(Last updated: June 7, 2004)

This document contains questions and responses on various aspects of IEEE-1588. These questions are not requests for an interpretation of the meaning of the standard or the resolution of apparent error. As such they are not ‘interpretations’ as described by the IEEE standards documents and represent only the opinions of the responders.

Ring topology: Ethernet port *active* via Rapid Spanning Tree

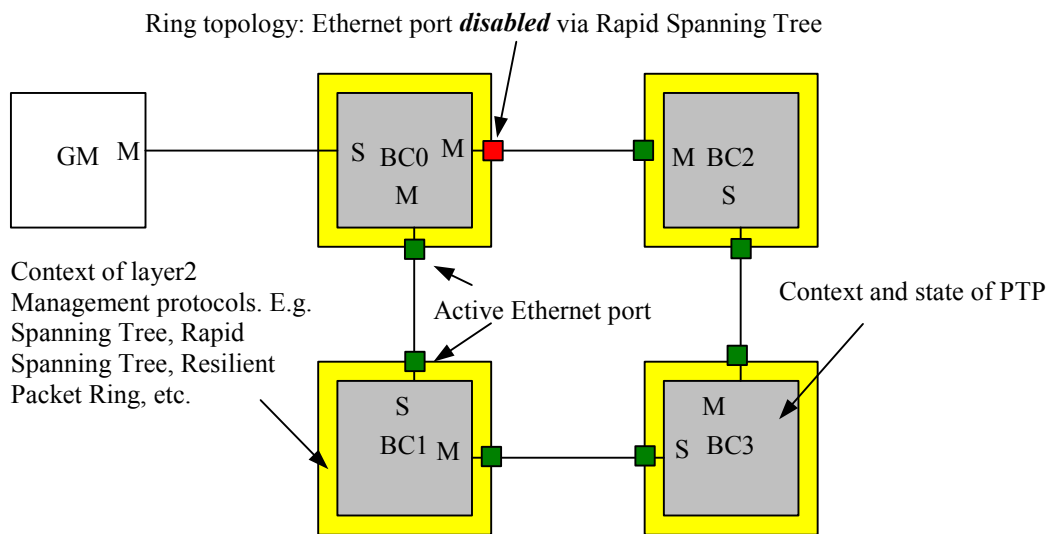
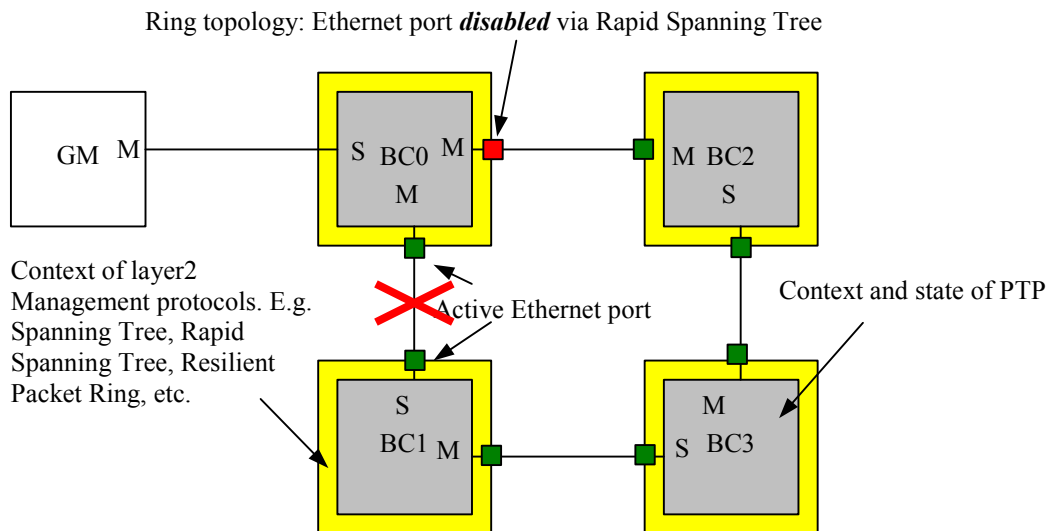
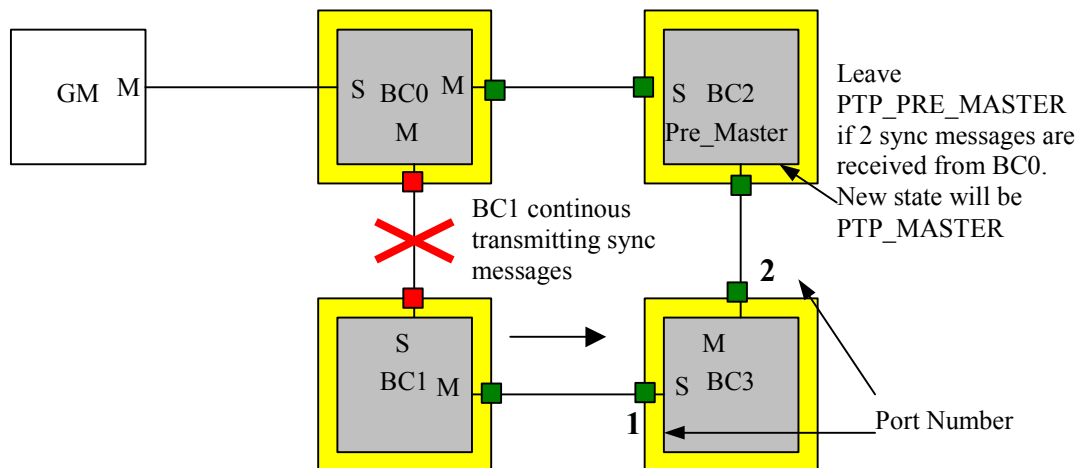
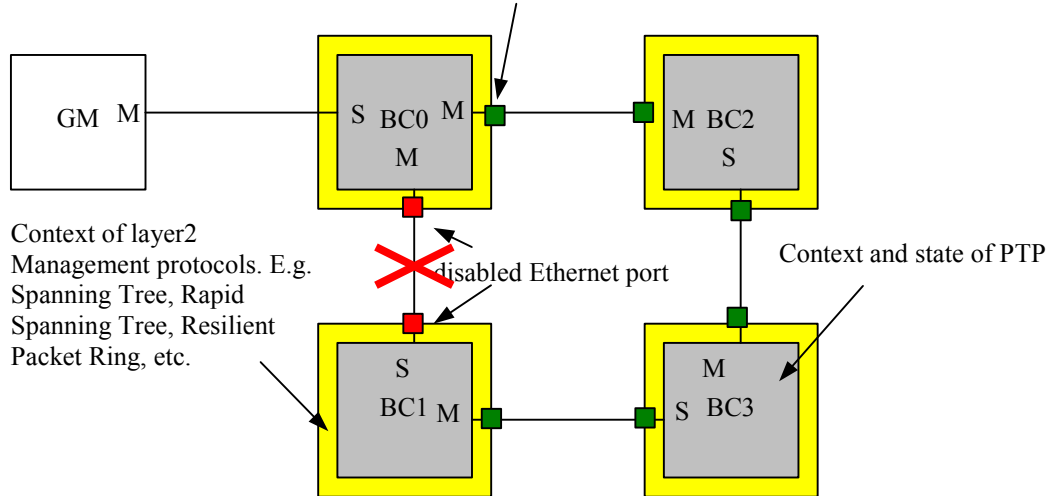
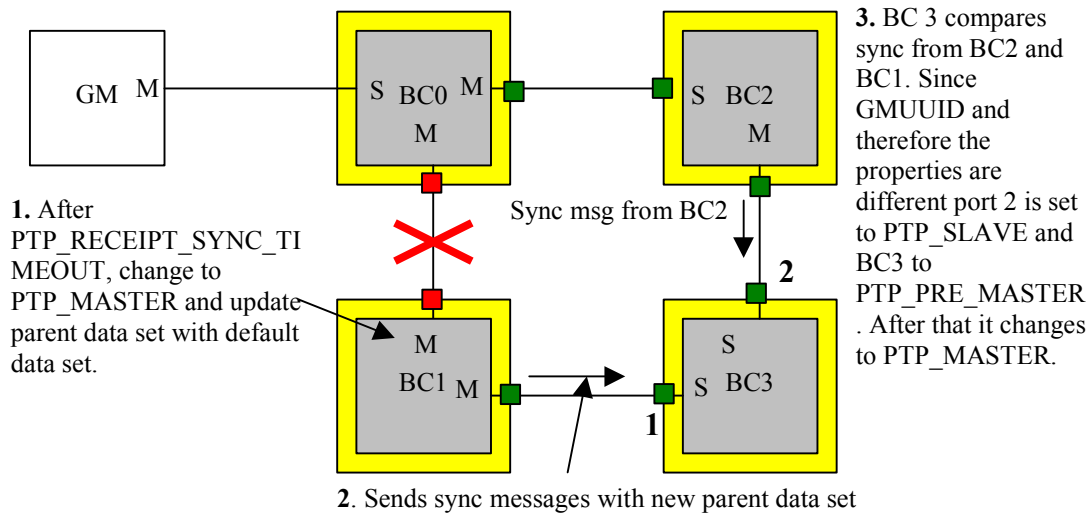
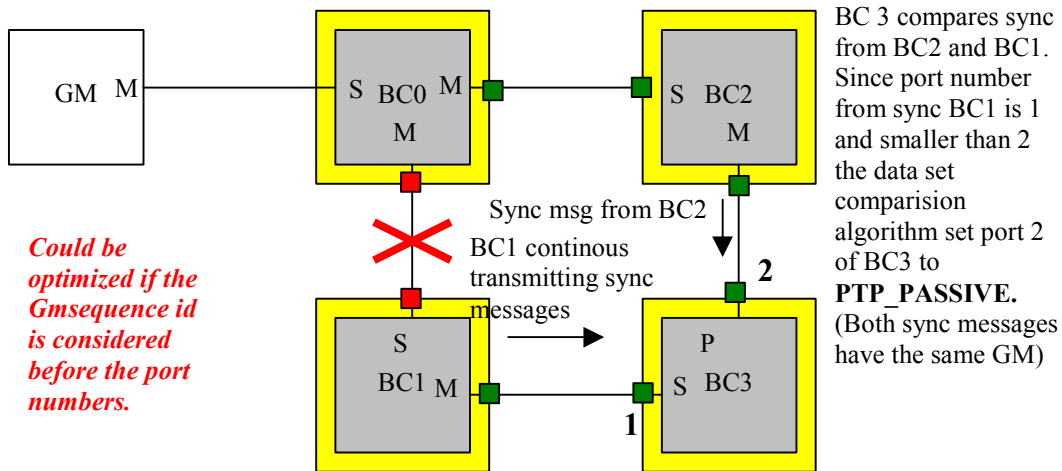
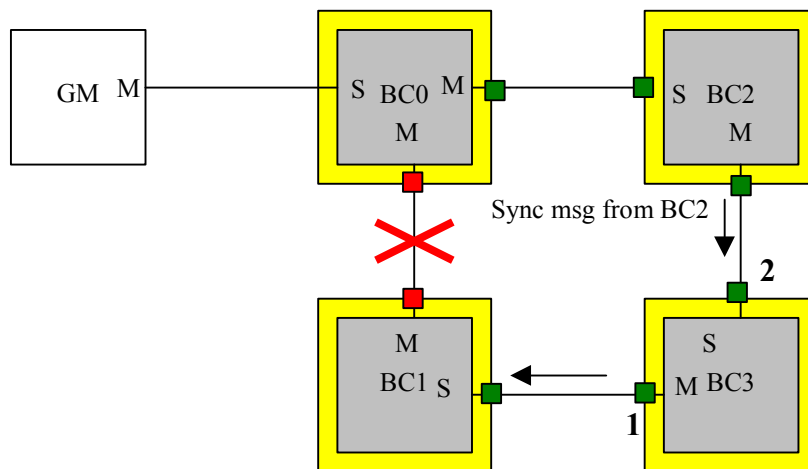
QUESTION 1: Possible optimization based on layer 2 protocols (submitted March 19, 2003)
Why does the BMC algorithm decides on the PortNumberReceiving before considering the GM SequenceID ? (please see the following figure source Figure 18)

This order causes sub-optimum (in terms of responsiveness) results in reconfiguring ring Networks. The 1588 algorithm converges but not as fast in this case as it would if the following suggestion is adopted. It occurs only if the steps removed fields are equal, to enter in the Data set comparison algorithm, part 3 Figure 19. If it is the case, the algorithm verifies first the PortnumberReceivingA with the PortNumberReceivingB. I think we should first check the GrandmastersequenceId of A and the GrandmastersequenceId of B to know which is the newer Sync Message. Otherwise we might trust the parent data set of the wrong BC for PTP_SYNC_RECEIPT_TIMEOUT seconds. If we first compare the GM_IDs the ring will be reconfigured faster.

The fundamental issue raised here is the trade-off between responsiveness to changes in network topology or clock properties and stability of the 1588 configuration with respect to transient conditions such as a missed packet. As written, the standard favors stability with respect to transients over responsiveness, with the threshold being 10 missed Sync messages. Bear in mind that a topology reconfiguration involves much more than simply picking new paths and possibly new grandmaster clocks. A change in topology also requires recalibration of the path length if the highest synchronization accuracy is to be achieved. This is one of the areas that needs operational experience to see if the current threshold is too conservative.

A second issue posed by the questioner is the interaction of two independent but not orthogonal protocols that can change the logical or physical topology of the network, in this case IEEE-1588 and any of the spanning tree protocols commonly used in Ethernet environments e.g. 802.1w. There are several points here:

- It is quite likely for many applications using IEEE-1588 that the underlying network does not use something like 802.1w. This still leaves the question (above) of whether the current threshold (10) in 1588 is too conservative.
- The proposed reversal of checking sequence Ids before port number equality may result in incorrect topology using 1588 in the absence of 802.1w. The logic represented by Figures 18, 19 and 20 are only invoked when the selection of master clock is based on topology.

- The goals of the topology portions of IEEE-1588 and a protocol like 802.1w are not the same. 802.1w seeks to configure the network as a minimum spanning tree. By contrast, if the subdomain contains multiple stratum 1 or 2, or preferred clocks, IEEE-1588 seeks to first partition (logically for purposes of 1588) the network into regions each served by a grandmaster clock. IEEE 1588 does this partitioning such that each region forms a minimum spanning tree and to the extent possible the depth of the trees in the regions are similar.

The tradeoff between stability and responsiveness is an important issue and should be readdressed at the next revision based on actual experience.
